### CODE COMPLIANCE CERTIFICATE

Consent No: 160621

New two bedroom sleepout.

### BC 160621

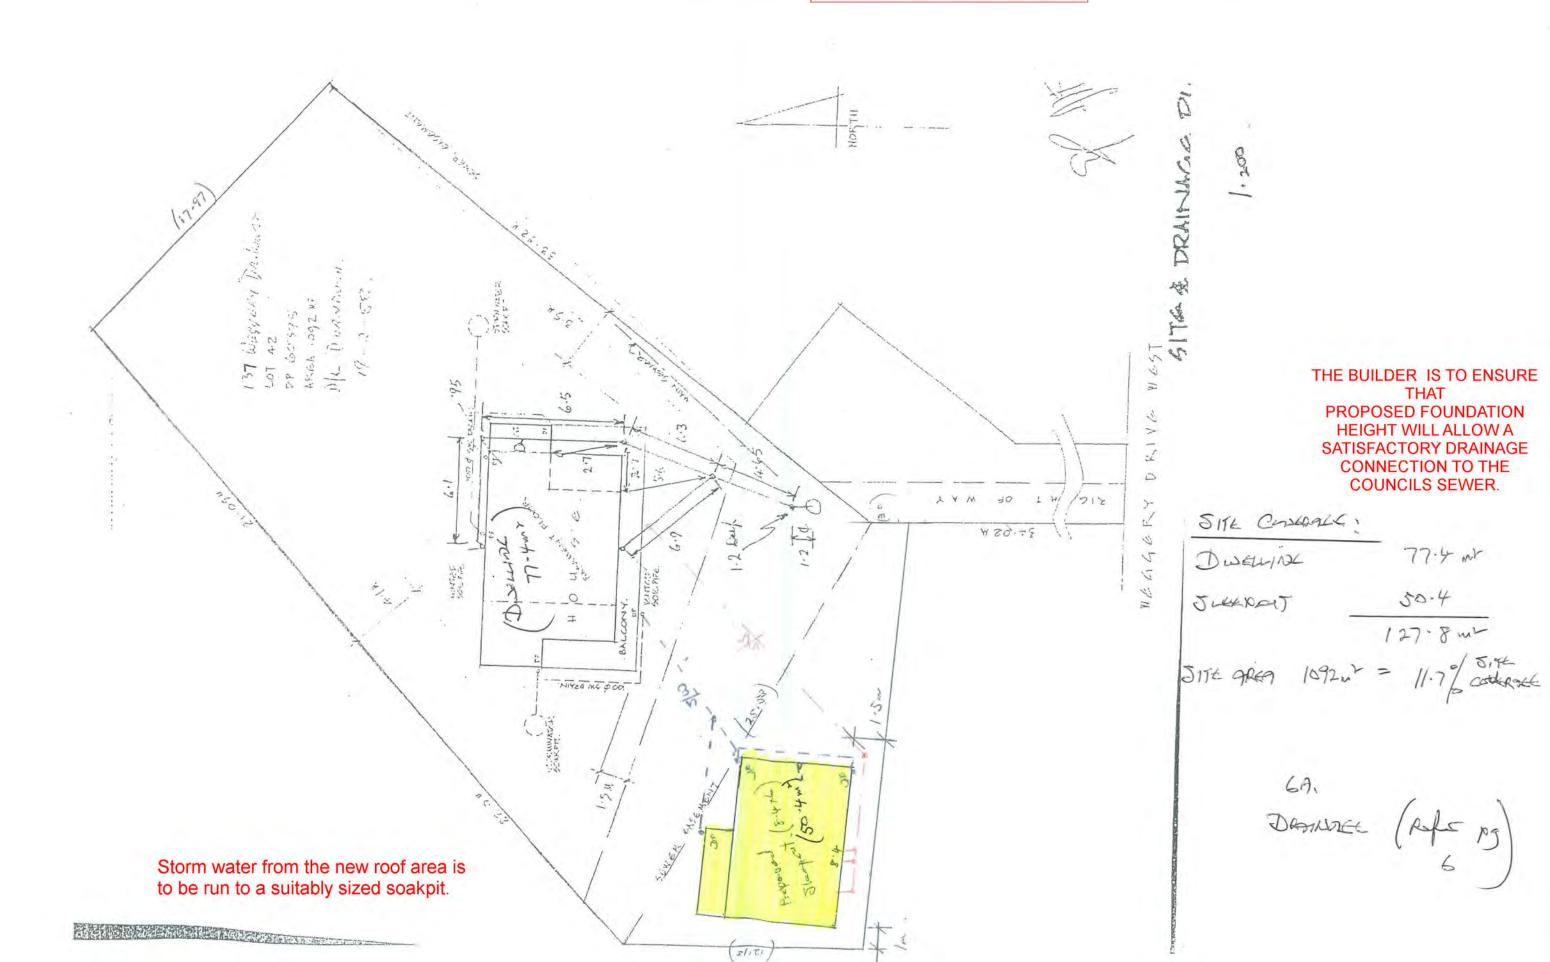
Ensure that the sleepout is not sited over any easements

The Owner/Builder is responsible for clearly defining the site boundary lines and pegs. This may require a survey.

FLOOR PLAN

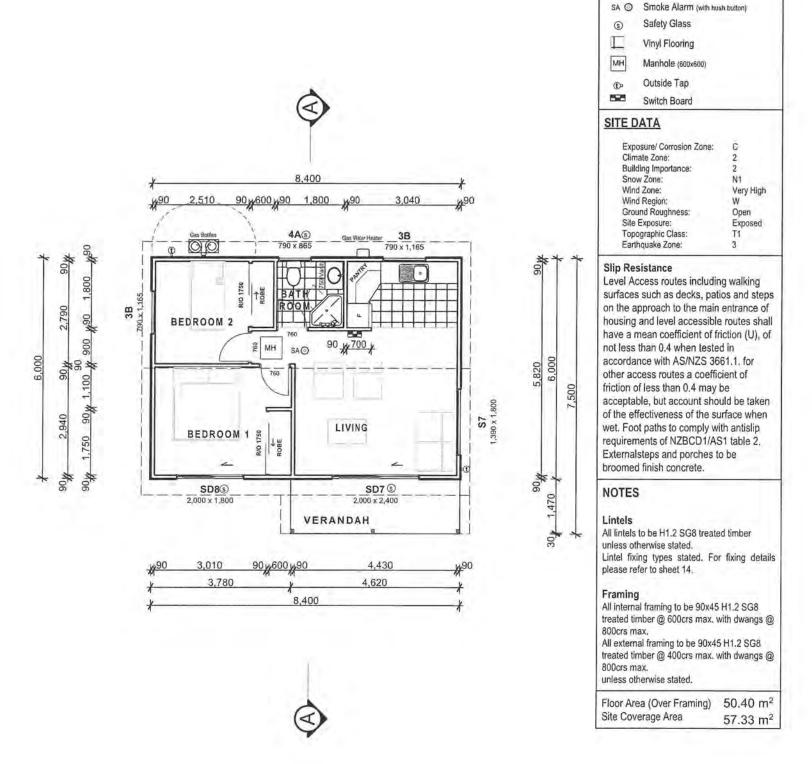
A certifying gas fitter is to provide a compliance certificate to council.

Hot water pipework from the HWC is to be insulated in accordance with NZBC H1.

ELECTRICAL PLAN

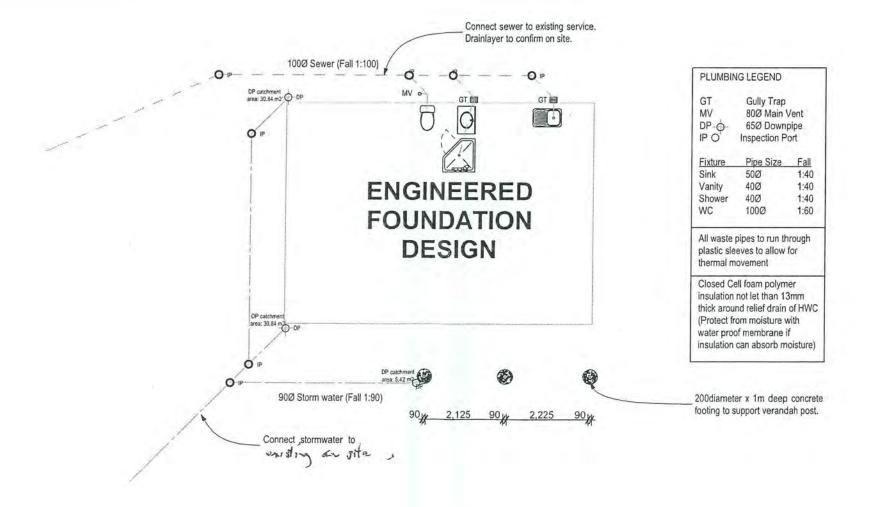
Provide electrical certification after completion and prior to Code Compliance Certificate being issued

FOUNDATION PLAN

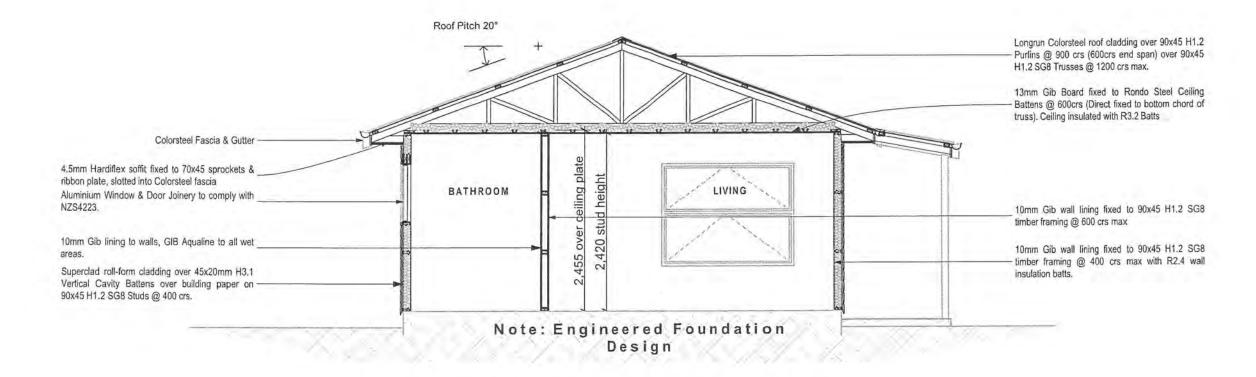
PROPOSED FOUNDATION
HEIGHT WILL ALLOW A
SATISFACTORY DRAINAGE
CONNECTION TO THE
COUNCILS SEWER.

This project contains elements specifically designed by an engineer. The owner/builder is required to ensure the engineer inspects the work and provides KCDC with written evidence of the inspection.

A drainage inspection is required.

A CERTIFYING PLUMBER/DRAINLAYER TO FILL OUT ATTACHED PRODUCER STATEMENT FORMS AND RETURN TO COUNCIL .ALSO PROVIDE NEAT ASBUILT DRAINAGE PLAN SHOWING SEWER STORMWATER AND WATER.
